SUBDIVISION REPORT - CONCEPT

► FILE #:	7-SB-21-C	AGENDA ITEM #:	21
POSTPONEMENT(S):	7/8/2021 - 10/14/2021	AGENDA DATE:	11/10/2021
► SUBDIVISION:	CAPITAL DRIVE		
► APPLICANT/DEVELOPER:	PATRICK SCHAAD TRUSTEE		
OWNER(S):	Schaad Residential Real Estate		
<hr/>			
TAX IDENTIFICATION:	131 122 & 122.24 (PART OF)	View map on KGIS	
JURISDICTION:	County Commission District 3		
STREET ADDRESS:	9933 & 0 Kingston Pk.		
► LOCATION:	North side of Kingston Pike at Capital Drive		
SECTOR PLAN:	Southwest County		
GROWTH POLICY PLAN:	Urban Growth Area		
WATERSHED:	Sinking Creek		
► APPROXIMATE ACREAGE:	2.153 acres		
<hr/>			
► ZONING:	CB (Business and Manufacturing)		
► EXISTING LAND USE:	Retail store, vacant land		
► PROPOSED USE:	Commercial subdivision		
SURROUNDING LAND USE AND ZONING:	North: Vacant land -- CB (Business and Manufacturing) South: Kingston Pike -- OP (Office Park) and PC (Planned Commercial) East: Church -- C-H-1 (Highway Commercial) West: Retail and vacant land -- I-G (General Industrial) and C-H-2 (Highway Commercial)

**7-SB-21-C
CONCEPT PLAN**

TYPICAL ROAD SECTION
THRU 60' ROAD
"PUBLIC ROAD"

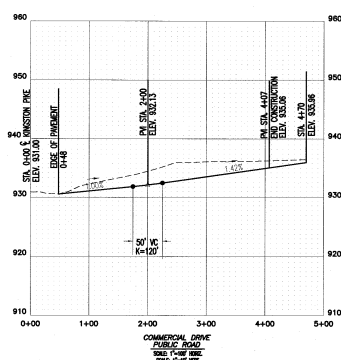
1. Revising the sidewalk design to meet requirements of Knox County Engineering and Public Works, City of Knoxville Department of Engineering, and/or Tennessee Department of Transportation.

3. Modifying the existing stormwater ponds on lots 1 & 4 to meet the Knox County Stormwater Management Ordinance.
4. Installing notification of future street connection at the north end of Commercial Drive as required by Section 3.04.C.2.d. of the Knoxville-Knox County Subdivision Regulations.

The existing detention ponds on lots 1 and 4 will be modified with the installation of the new road, however, the concept plan does not show a preliminary design for these modifications. The primary concern is how the pond on Lot 4 will impact the parking lot design for the existing business and the applicant has indicated the detention pond will be moved underground.

12. VEHICULAR ACCESS FOR ALL LOTS IS LIMITED TO INTERIOR ROAD SYSTEM ONLY.
 13. THE TWO EXISTING DETENTION BASINS ARE IMPROVED BY CONSTRUCTION OF ROAD "A". THE NEW POND WILL HAVE THE SAME VOLUME AS THE EXISTING POND. THE IMPERVIOUS AREA WILL BE LESS AFTER REDEVELOPMENT.

Figure 9

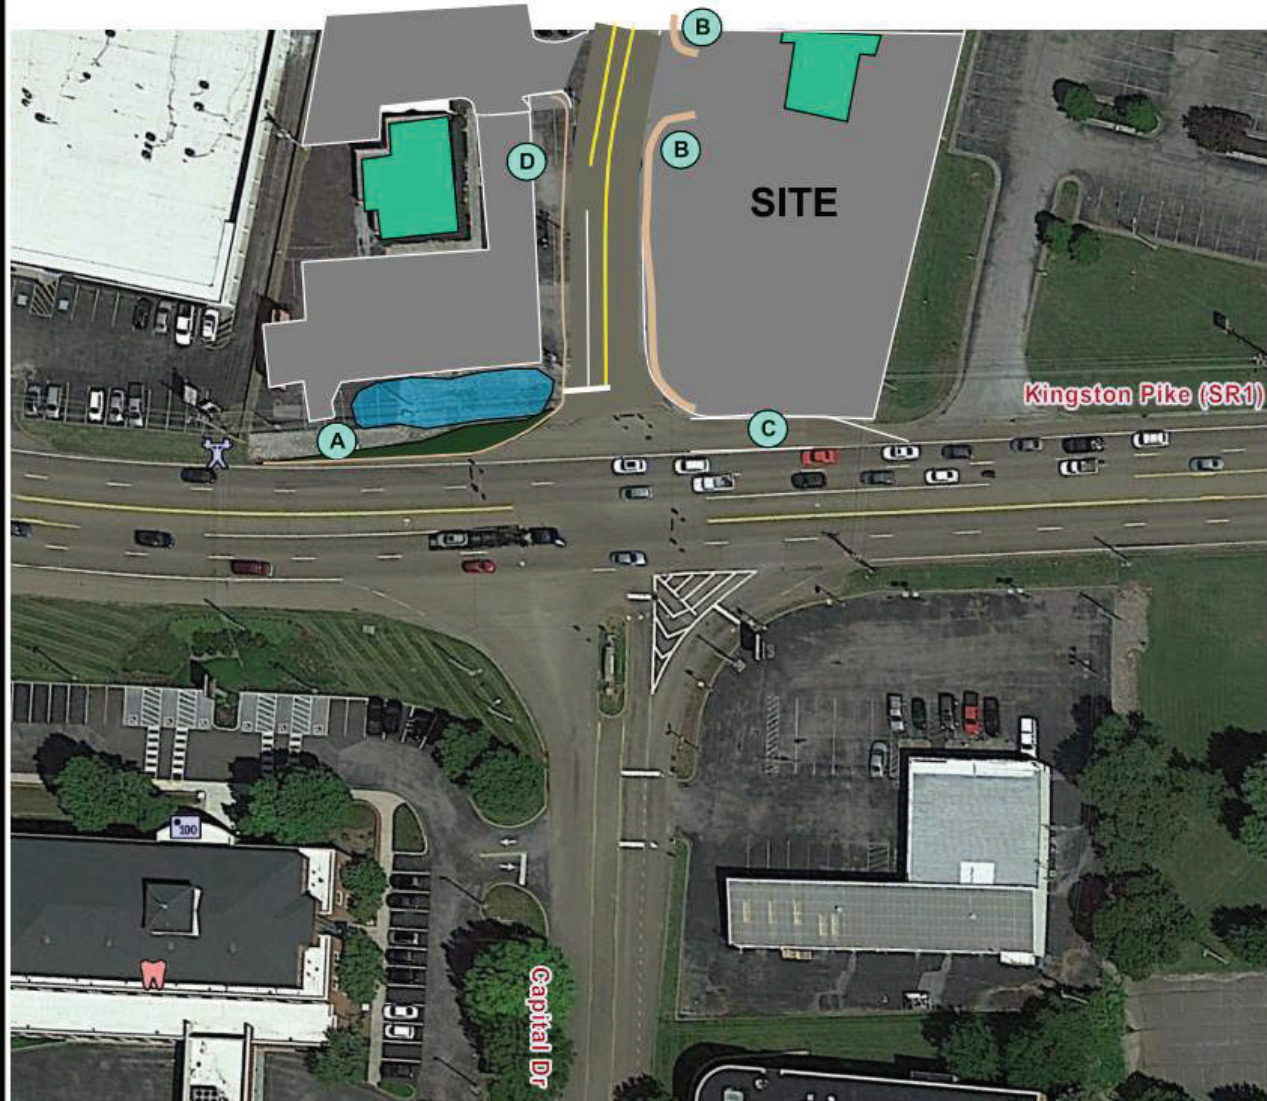
- Provide 100-foot storage for a left-turn lane on the new connector stub road at the southbound approach to Kingston Pike as shown in **Figure 9**.
 - Ensure there are no driveway openings to the GemStore and proposed retail developments within this storage length.

- Maintain the existing configuration of the northbound approach on Capital Drive to provide a shared left-through lane and a separate right-turn lane as shown in **Figure 9**.

- Provide a 50-foot storage westbound right-turn lane on Kingston Pike via appropriate striping as shown in **Figure 9**.
- Any sidewalks constructed within the proposed site along the connector stub road will require the construction of ADA-compliant curb ramps on any connecting corners of site driveways. Post STOP signs (R1-1) for exiting traffic from the GemStore, proposed coffee/donut shop, and proposed retail strip development driveways located along the new connector road north of Kingston Pike.

- A. Tightening intersection layout requires asphalt removal. Likely to include utility and drainage impacts.
- B. ADA-compliant curb ramps required, including detectable warning surface and turning space behind ramp.
- C. Striping of turn lane assumes shoulder is full depth.
- D. Stub road construction will require modification of access and parking at GemStore jewelry store.

Figure 3: Projected 2026 AM Peak Hour Time-Space Diagram

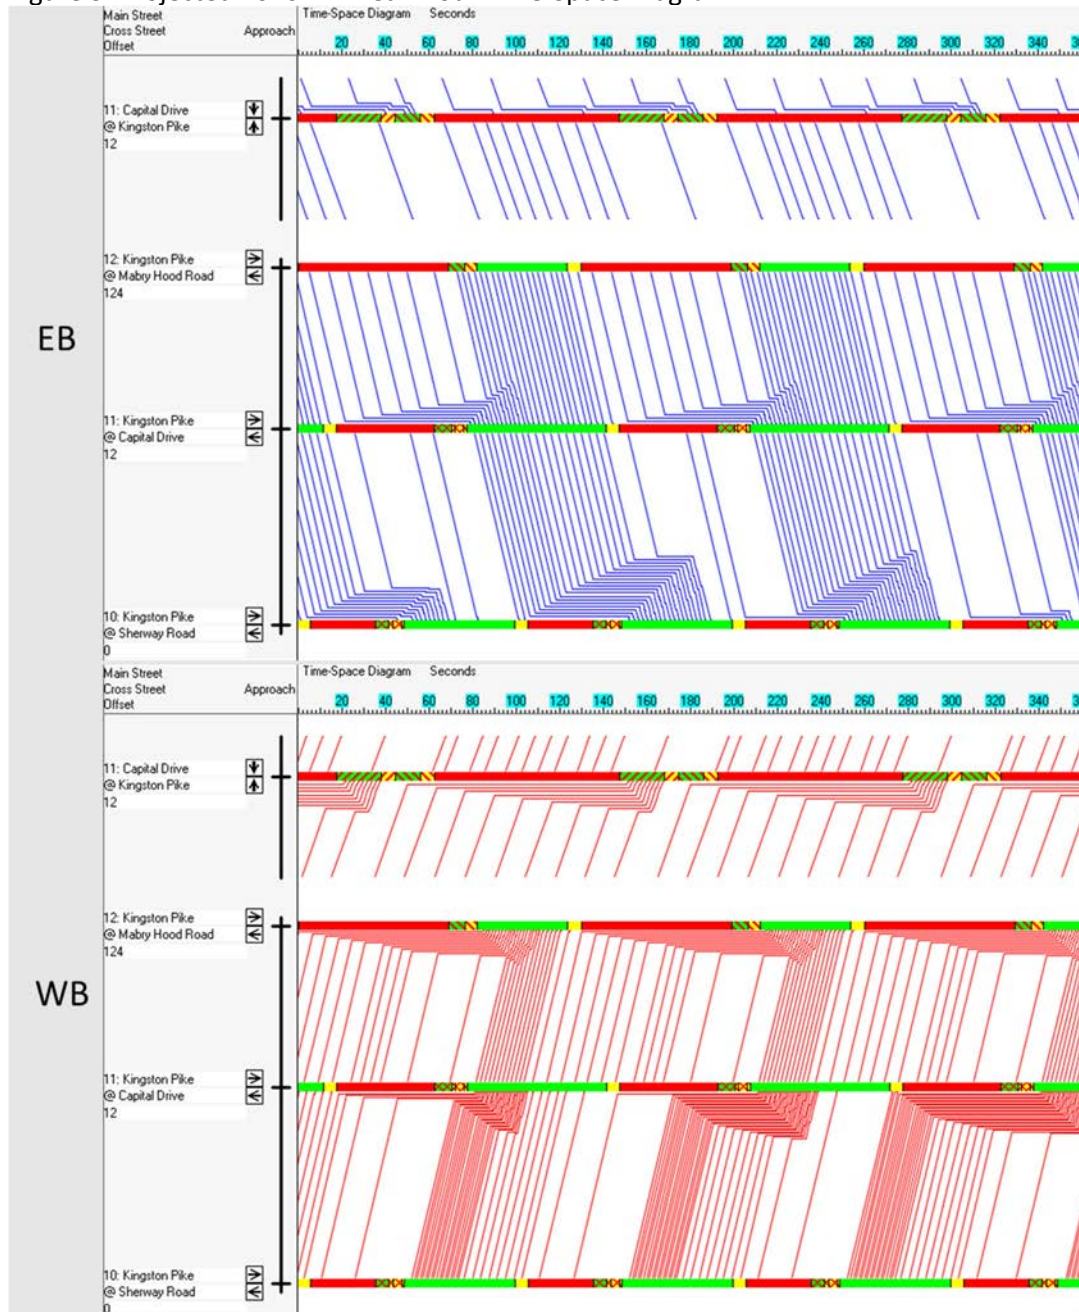
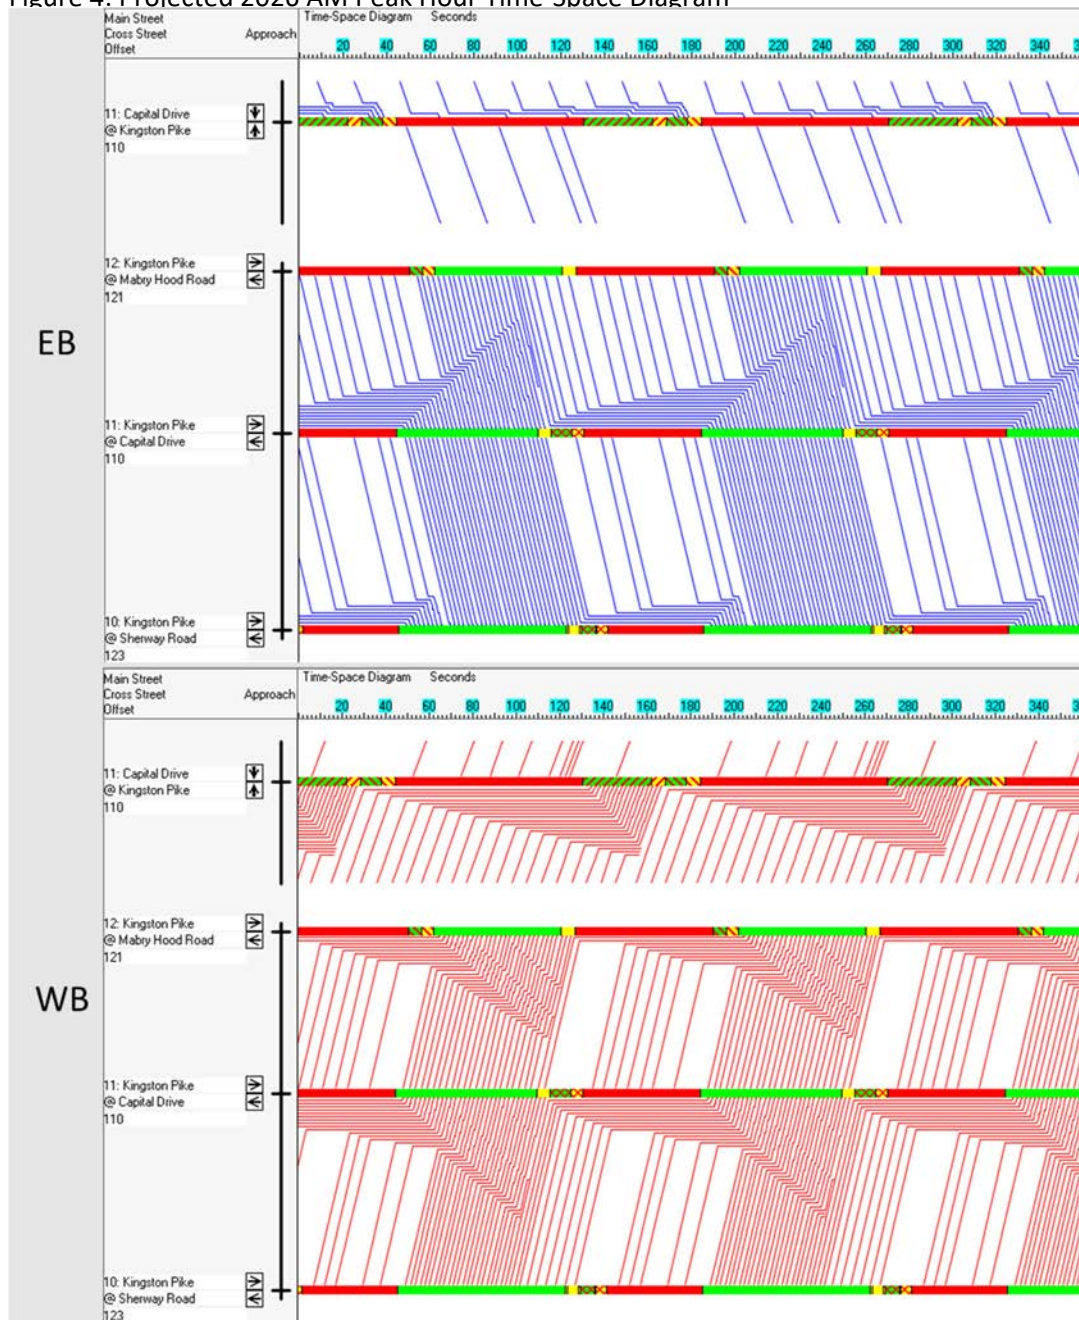
The split-phase operation of the signal at Capital Drive and additional traffic has both positive and negative impacts to the traffic progression along Kingston Pike as portrayed in SimTraffic visualizations and Synchro time-space diagrams, as shown in Figures 3 and 4. In the AM peak hour, with the offset optimization, eastbound progression improves, as traffic is more likely to proceed through Capital Drive during all eastbound green time at Mabry Hood Road. Some stops or queuing are expected at the approach to Sherway Road, which is not different than currently observed. Westbound AM peak hour traffic is more likely to encounter a stop or queue at Capital Drive, but experience stops and queueing at Mabry Hood as observed today. In the PM peak hour, eastbound traffic is more likely to be encounter a stop or queue at Capital Drive; yet is more likely to proceed through Sherway Road than currently observed. Similarly, traffic is more likely to encounter a queue or stop at Capital Drive from Sherway Road in the westbound direction; yet, progression is similar between Capital Drive and Mabry Hood Road as today.

Figure 5: Projected 2026 AM Peak Hour Time-Space Diagram with Three-Lane Northbound Capital Drive

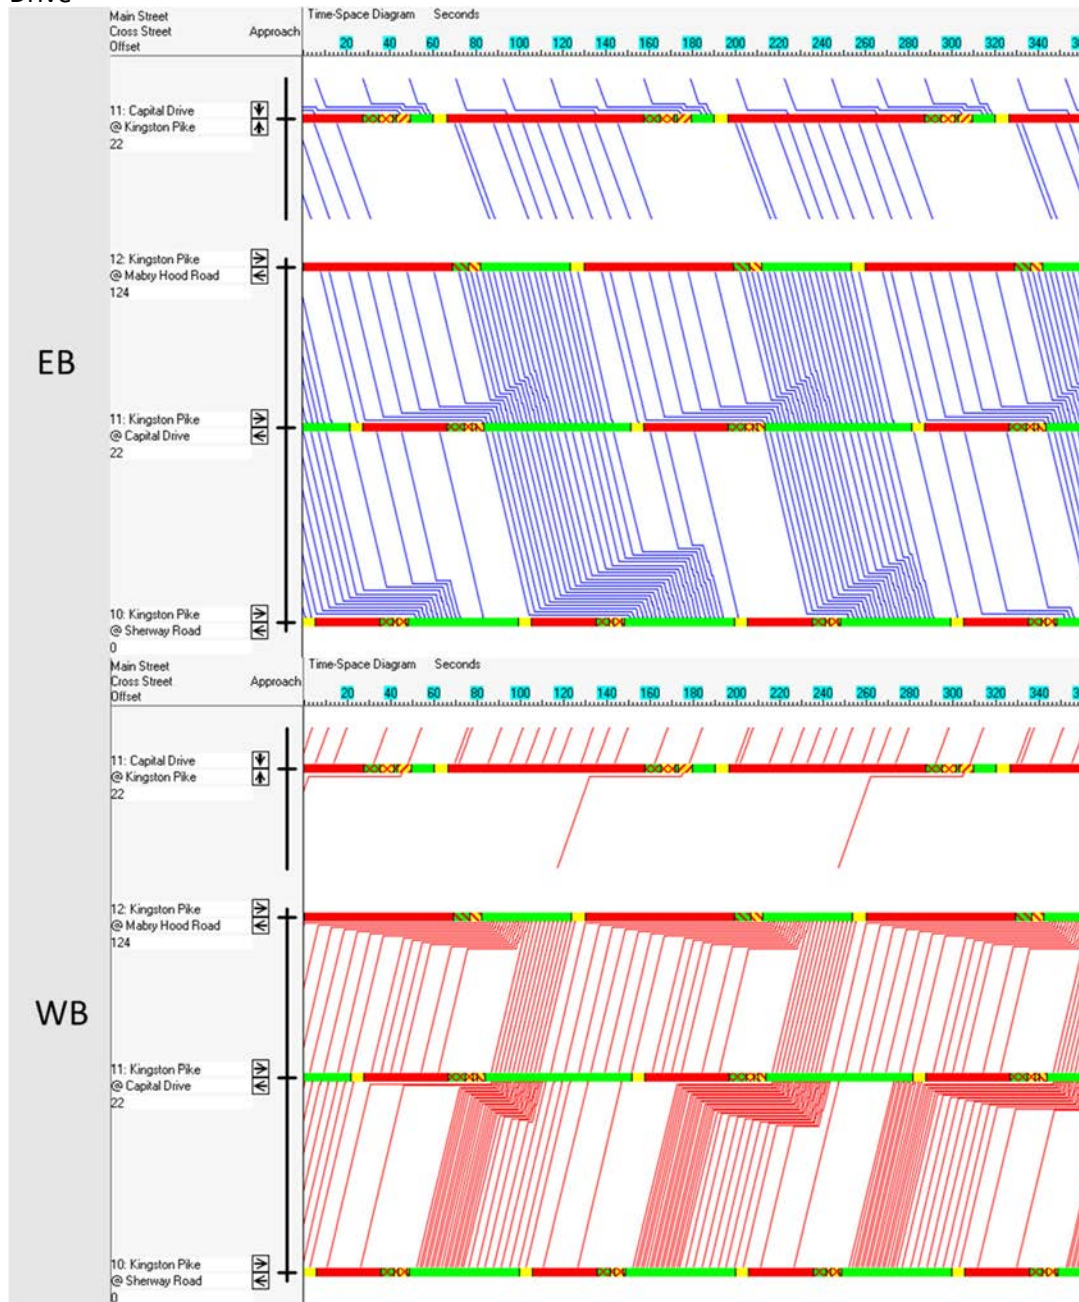
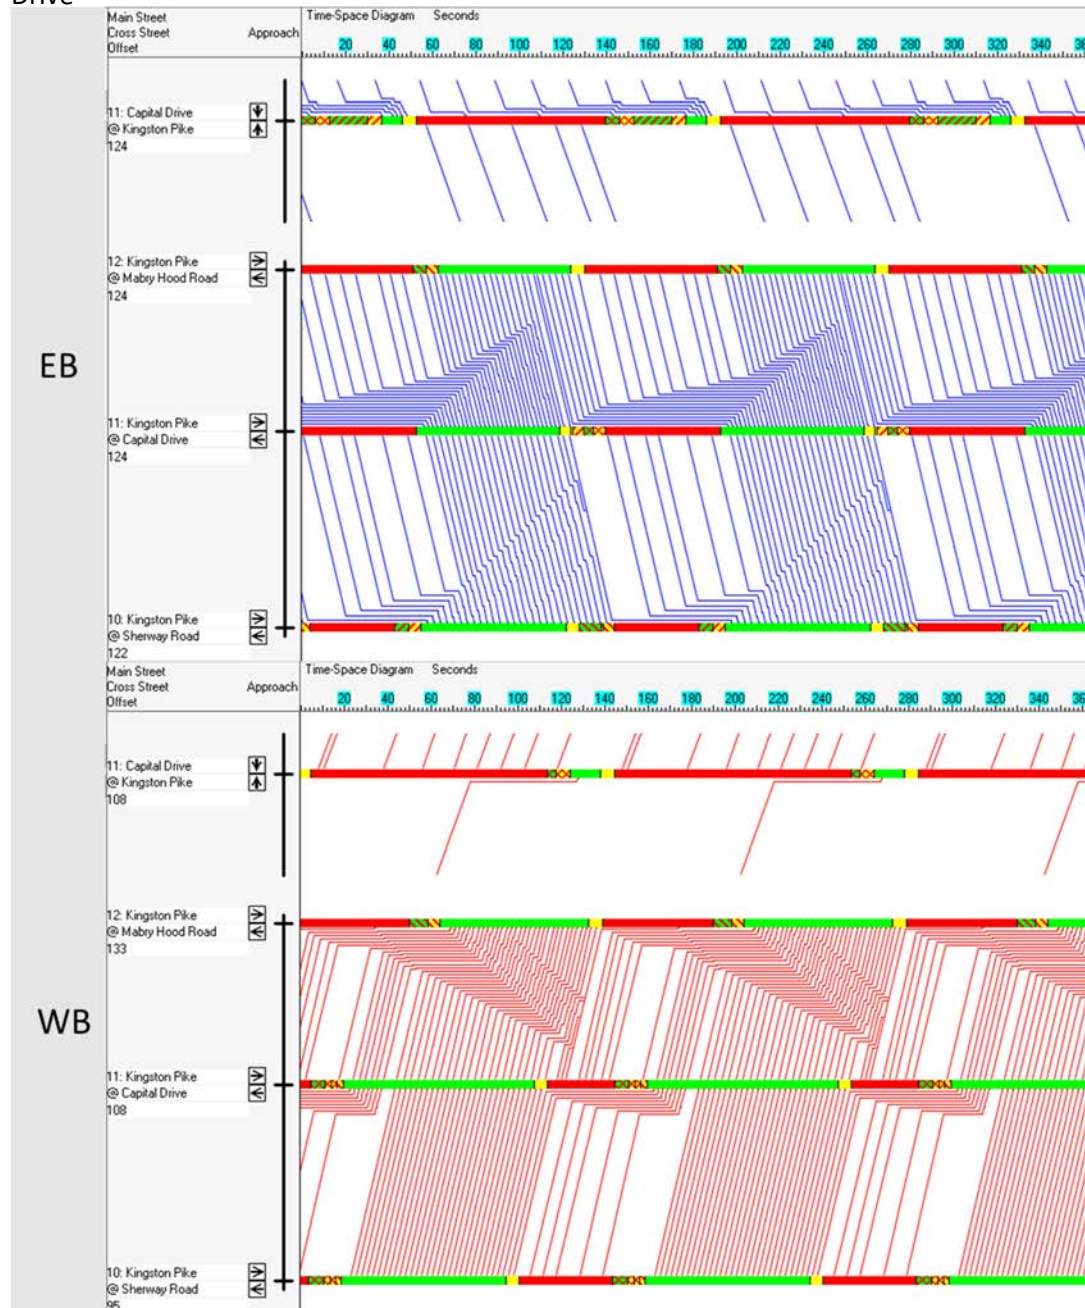
The initial recommendations of the Capital Drive Retail Development traffic impact study proposes that the northbound approach at Capital Drive be reconfigured to provide separate left, through, and right turn lanes, provided that the landscaped median can be removed and monument sign relocated. With the three-lane approach, the signal would operate under conventional phasing with additional left-turn phases for all approaches. For comparison purposes, additional analysis was conducted to compare the signal operations and Kingston Pike progression should Capital Drive be modified to provide a three-lane northbound approach. Using existing signal cycle lengths and optimized offsets, there are minimal differences between v/c ratios, delays, and northbound queues between the two- or three-lane configurations as shown in Table 3; however, westbound traffic along Kingston Pike between Capital Drive and Mabry Hood Road are negatively impacted by the different signal operations, specifically during the PM peak hour. Simulations in SimTraffic and Synchro time-space diagrams illustrated in Figures 5 and 6 show that westbound queues at Mabry Hood Road are expected to increase to near the entire distance to Capital Drive due to the added traffic on Kingston Pike and the wait time for the split-phase at Mabry Hood. With Capital Drive operating as a split-phased signal, this additional traffic is held at Capital Drive before being released to Mabry Hood Road and is likely to progress through the signal. As shown in Table 2, the worst-case queues expected at Capital Drive in the westbound approach are approximately 575 feet, which can be stored with no impacts to Sherway Road.
